CHANGE ORDER NUMBER: 3

2C: Differing Site Conditions (unforeseeable). New development (conditions changing after PS&E completed). This Change Order revises various items requested by Austin Energy after the project began. The conduit layout on the project was revised to include the relocation of the electrical service pole and foundation out of the sidewalk. Austin Energy also requested revisions to the callouts on the ground boxes for identification purposes and reduced the wiring for illumination poles. This Change Order adds a pay item to widen the 6' sidewalk to 8' wide to eliminate the need for a bike lane in the existing vehicle travel lane.

**Lakeline Right Turn Lane
Williamson County Project No. 1809-259**

Change Order No. 3

2851 1/2 S. LAKELINE BLVD.
LAKELINE TURN LANE
**PROPOSED SIGNAL LAYOUT -
LAKELINE/ HEB DRIVEWAY**

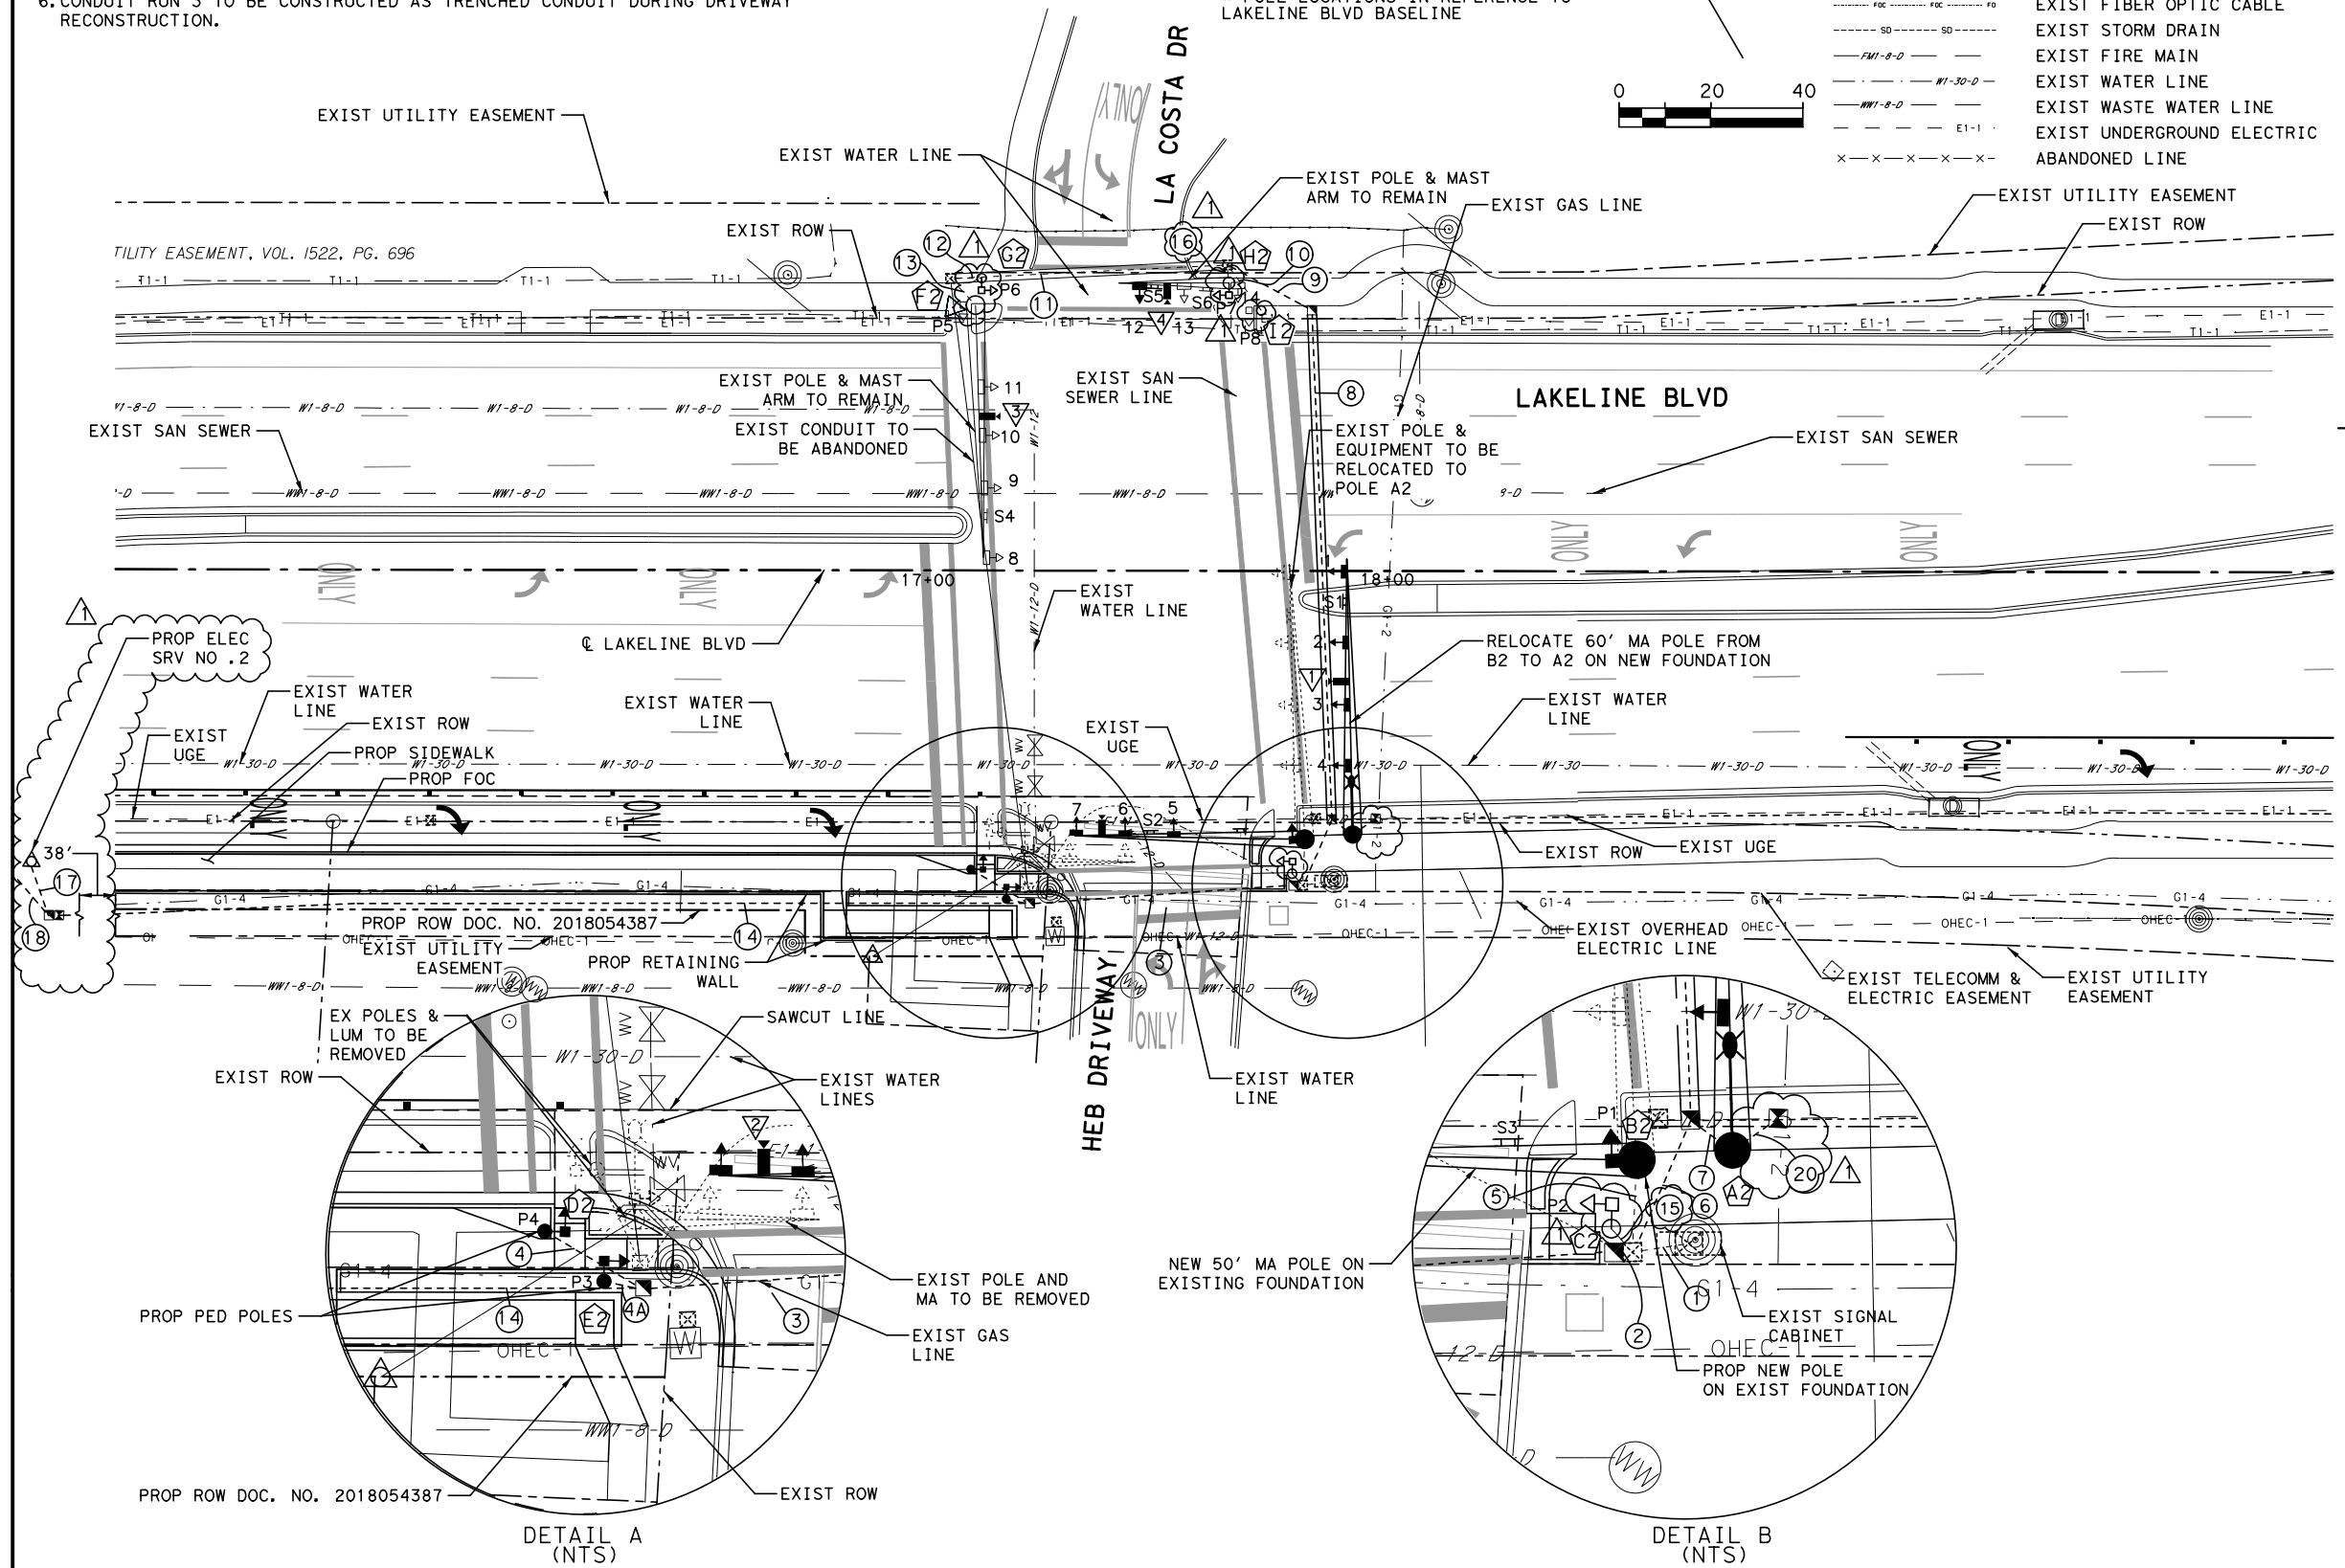
2. On the revised sheet 27, it is not clear what has actually changed. Since the wiring has changed, it is assumed that just the area of change has been bubbled. True? If not, please add call-outs to clarify changes. **Only changes were to ped head status as existing or proposed, conduit run numbers beyond run no. 14. Revision bubbles have been revised to be smaller / around the specific changes to clarify.**

3/5/19 PED SIGNAL/ILLUMINATION REVISIONS

2851 1/2 S. LAKELINE BLVD.
LAKELINE TURN LANE
SIGNAL ELEVATION -
LAKELINE/ HEB DRIVEWAY

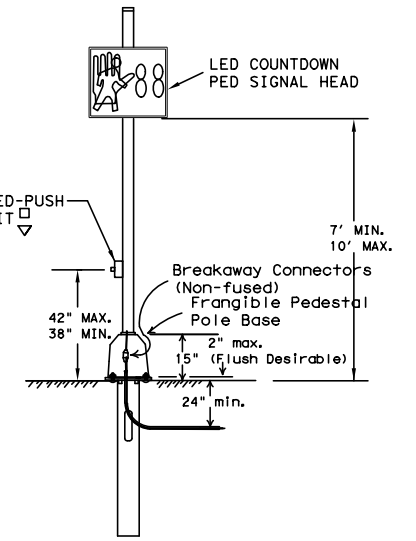
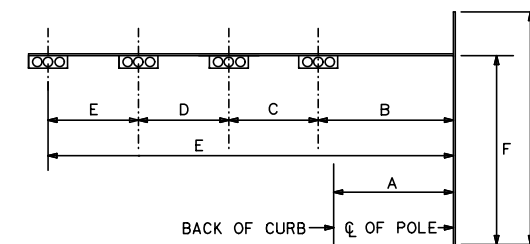
3. On revised sheet 28, it appears that only the call-outs have been updated to say which Ped signals are existing. Correct? **Correct – this is to clarify that these are to remain. Revised to state “Existing to Remain” in callouts to be more clear.**

2851 1/2 S. LAKELINE BLVD.
LAKELINE TURN LANE
ILLUMINATION LAYOUT

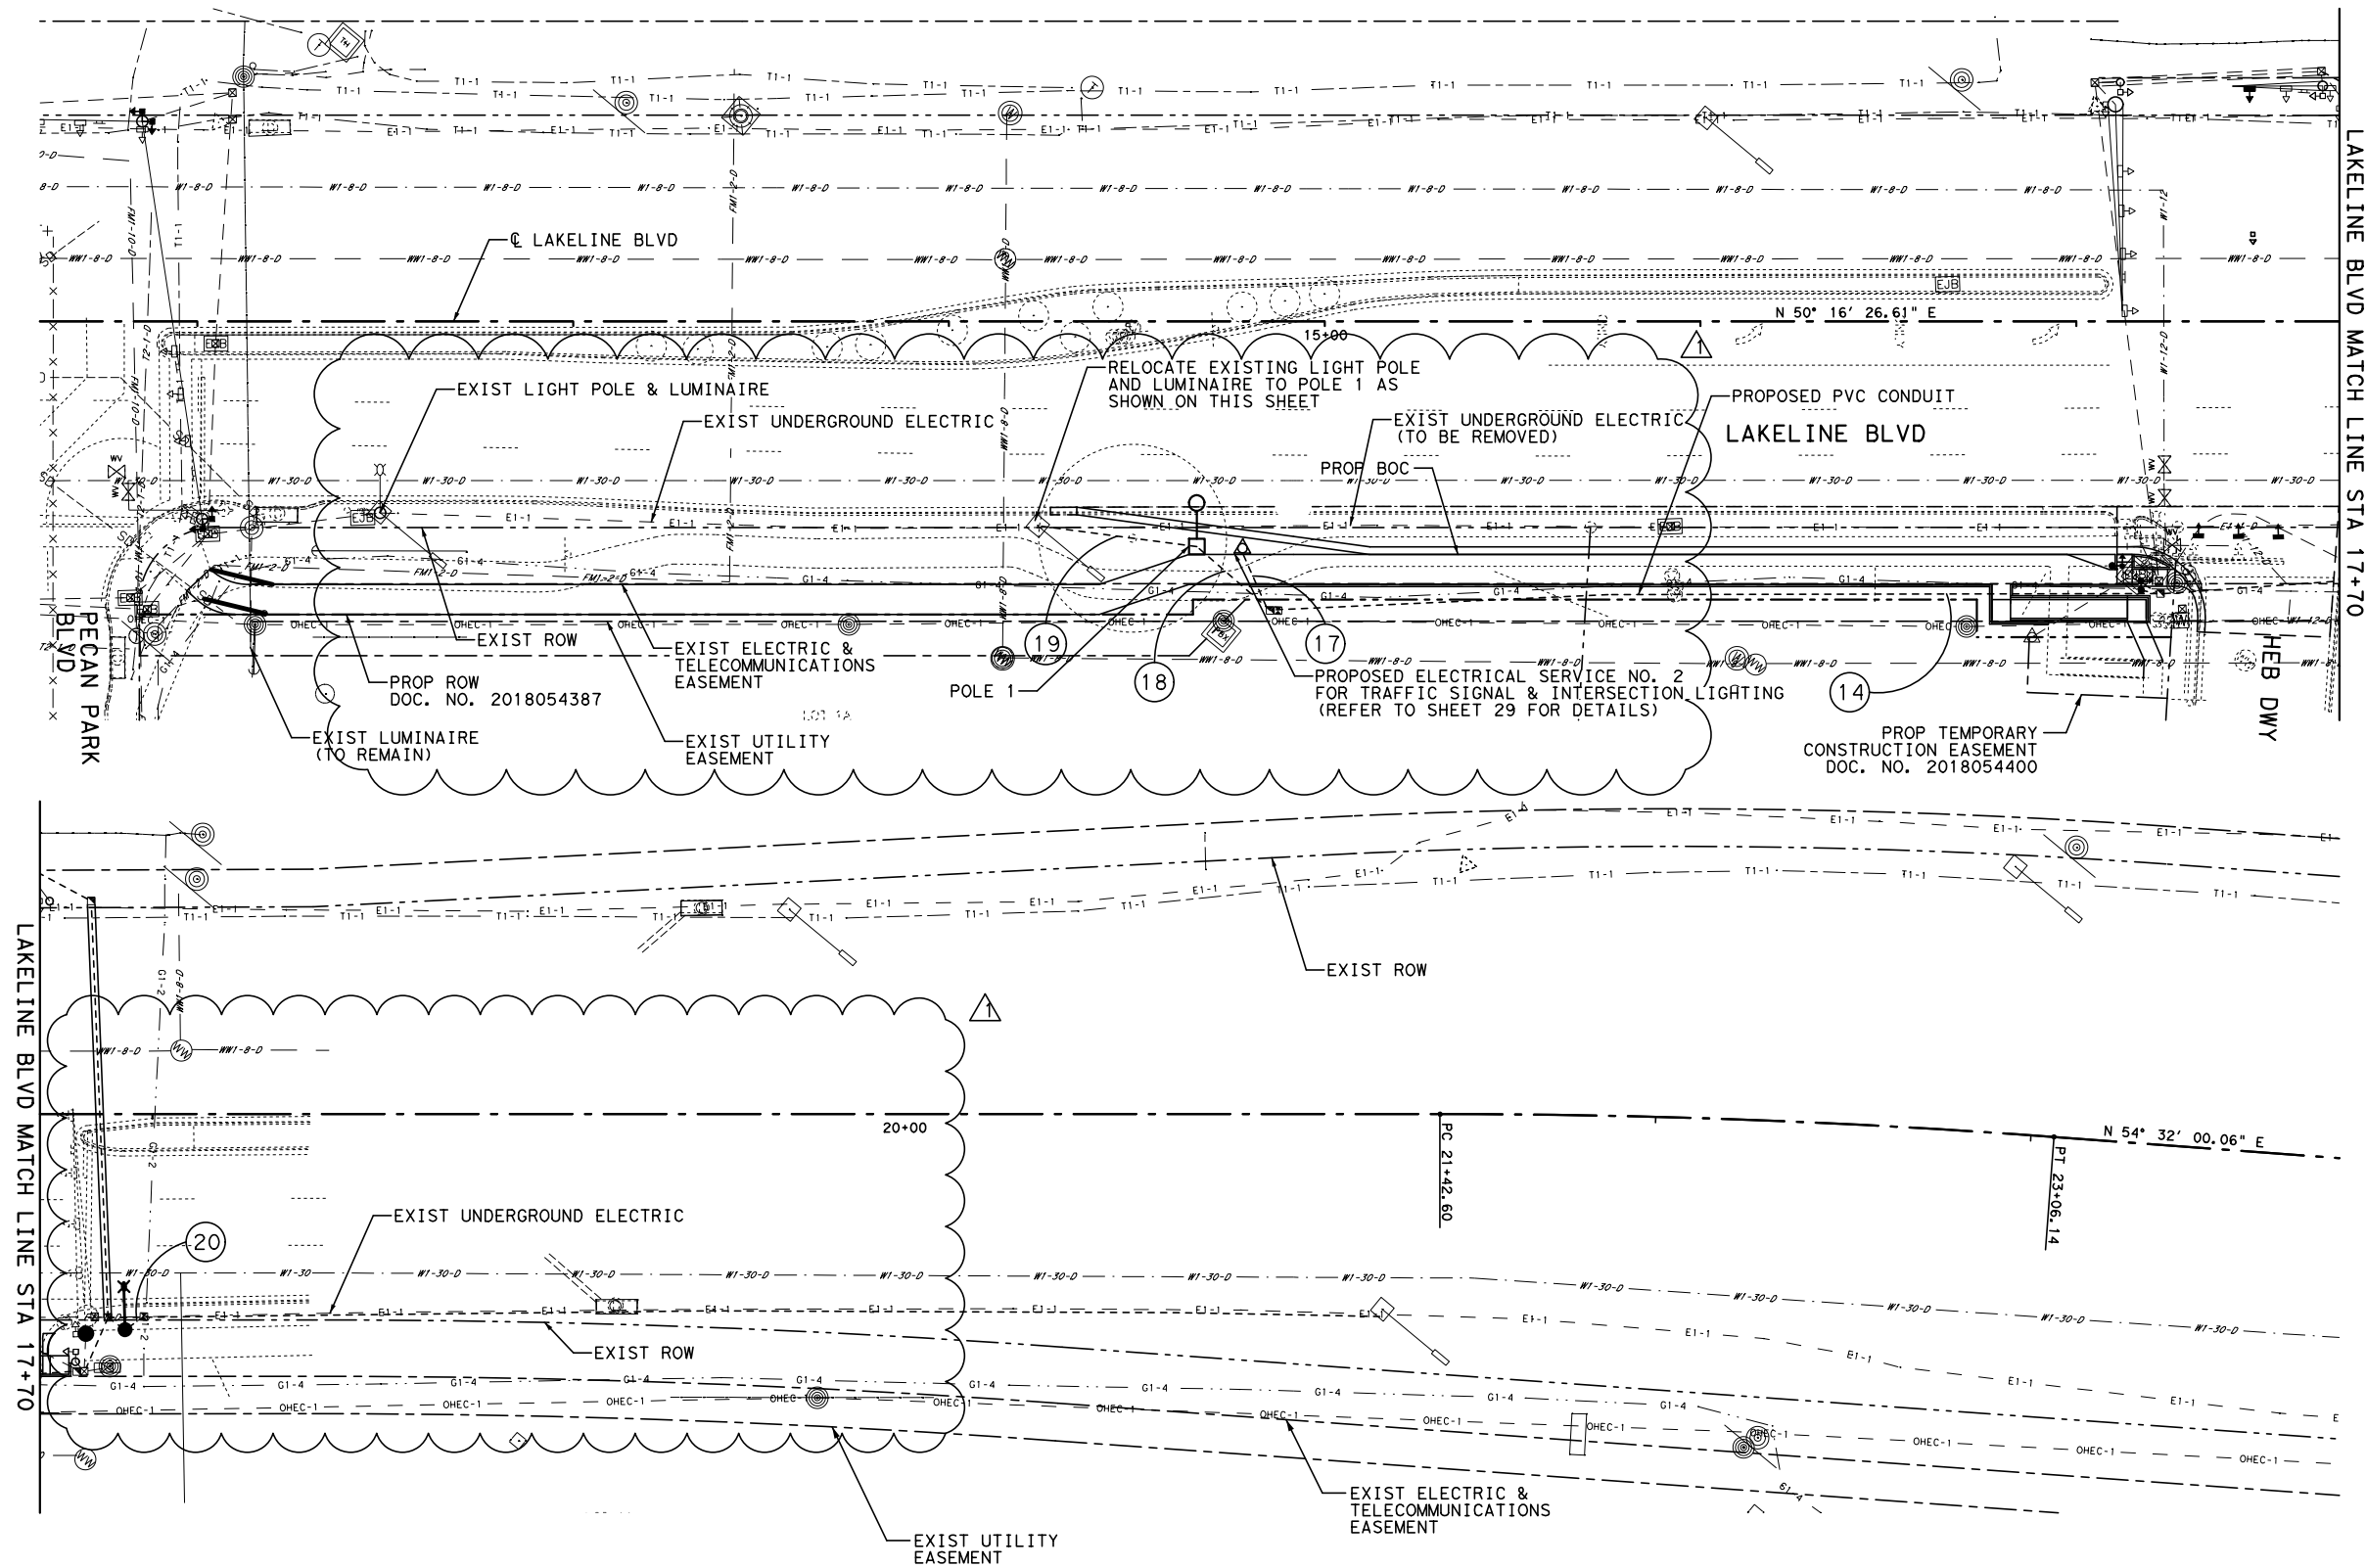
5. Revised sheet 31 has several quantity differences from the original plans that are not bubbled. Please update sheet and also provide a list of item numbers that have changed with their deltas. This will be used to create a draft Change Order. **Sheet updated and items with deltas provided in PDF attached.**
6. Since revised sheet 34 has poles and services, please update sheet table that shows stations and offsets for placement purposes. The revised sheet still shows the same numbers in the table as the original sheet, but the location has changed. **Previous sheet only showed roadway illumination Pole 1 station and offset (location unchanged from bid set). Pole 1 is the only new location roadway illumination pole. Station and Offset for Electrical Service No. 2 on sheet 34 has been added as a new table to clarify location of service pole.**

We have reviewed the RFI #9 and are currently coordinating with Austin Energy to determine any impacts to the existing illumination circuit related to RFI #12. As for the questions in RFI #9, our response pending coordination with Austin Energy are as follows. Regarding coordination of new service with Austin Energy and all associated applications (question 1), the general notes for Item 628 state that the contractor "shall make all arrangements for power", and thus the contractor should be coordinating the new service. The contact information at Austin Energy for this area is Ronald Solbach (P: 512-505-7145, E-mail: Ronald.solbach@austinenergy.com) As for the timing of the disconnect of existing power (question 2), the infrastructure required for the new electrical service should be in place prior to cutting off power to the two illumination poles being removed or relocated per sheet 34.

3/5/19 PED SIGNAL/ILLUMINATION REVISIONS
